Appendix C. CEQA Comment Letters

Notice of Availability of Draft Environmental Impact Report

Capitol Corridor Joint Powers Authority (CCJPA), the lead agency for the California Environmental Quality Act (CEQA), is issuing this Notice of Availability of a draft Environmental Impact Report (EIR) and virtual public meetings for the proposed South Bay Connect Project (Project). The proposed Project would relocate Capitol Corridor passenger rail service to the existing Union Pacific Railroad Coast Subdivision between Oakland and Newark to improve operational efficiency and reliability. The proposed Project also includes constructing a new passenger rail station on the Coast Subdivision at the existing Ardenwood Park-and-Ride to serve southern Alameda County passengers and facilitate connections to existing transbay transit services. The draft EIR describes the proposed Project and evaluates the potential environmental impacts associated with both the Project and the "no project" alternative.

FIGURE 1

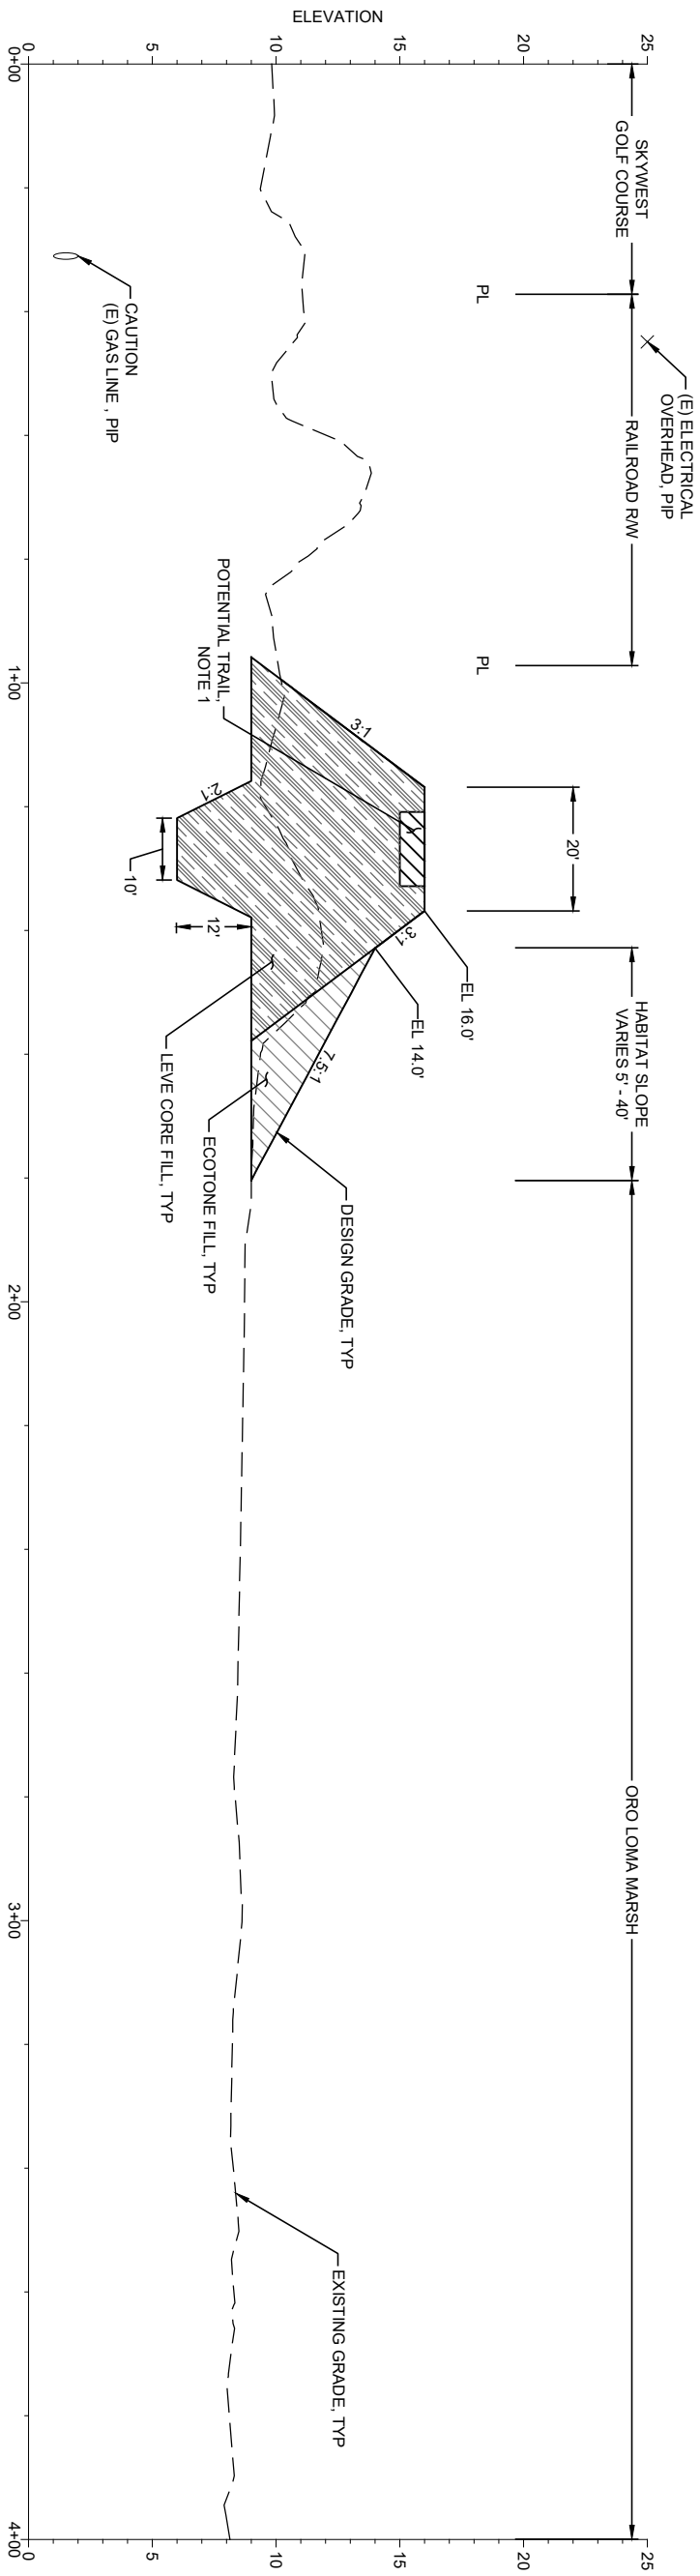
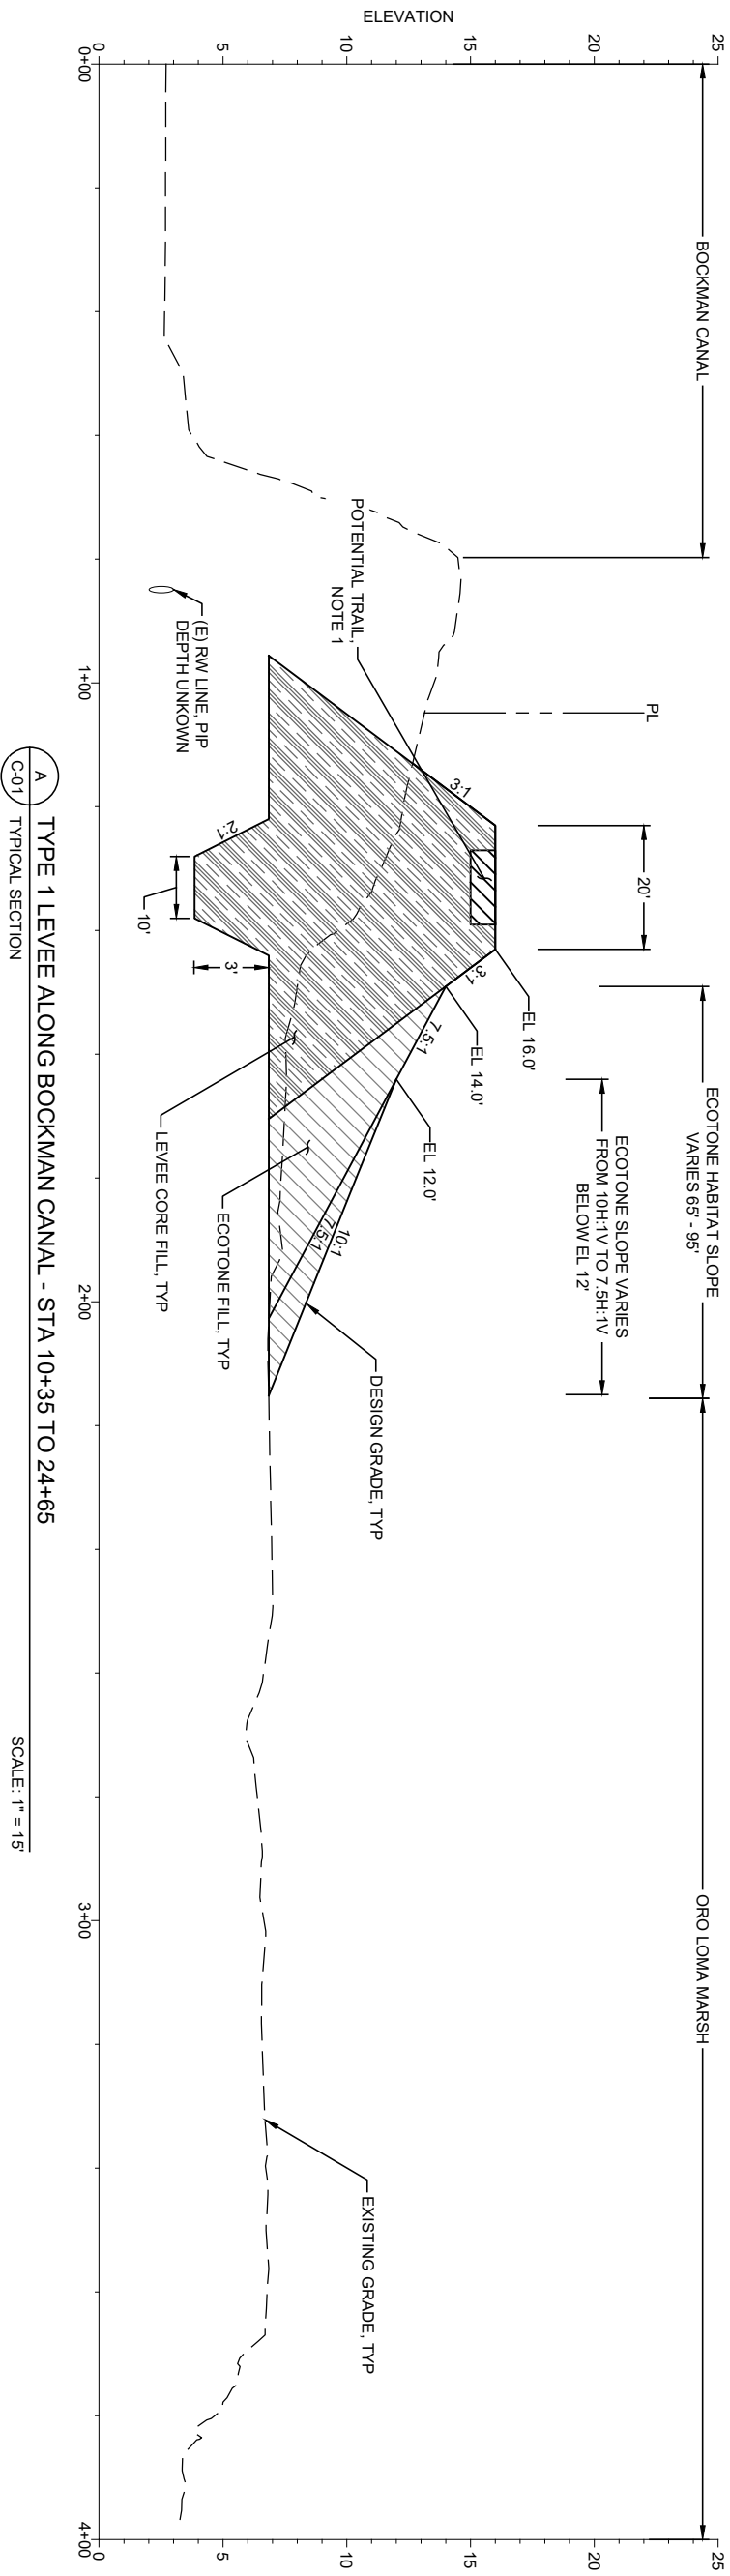
For over five years, EBDA has been the project manager and champion for the First Mile Horizontal Levee Project. This project, which is a key element of the [Hayward Regional Shoreline Adaptation Master Plan](#), would improve water quality in the Bay by providing additional wastewater polishing, provide upland refugia and enhanced habitat, and provide flood protection in the face of sea level rise for communities and infrastructure in Hayward and San Lorenzo. As shown in Figure 1, the project is located at the back of Oro Loma Marsh along the same corridor as proposed for the South Bay Connect Project segments C and D (see DEIR Figures 2.4 and 2.5). The First Mile Project has recently completed 30% design, and we have recently been awarded grant funding to continue work through final design and CEQA.
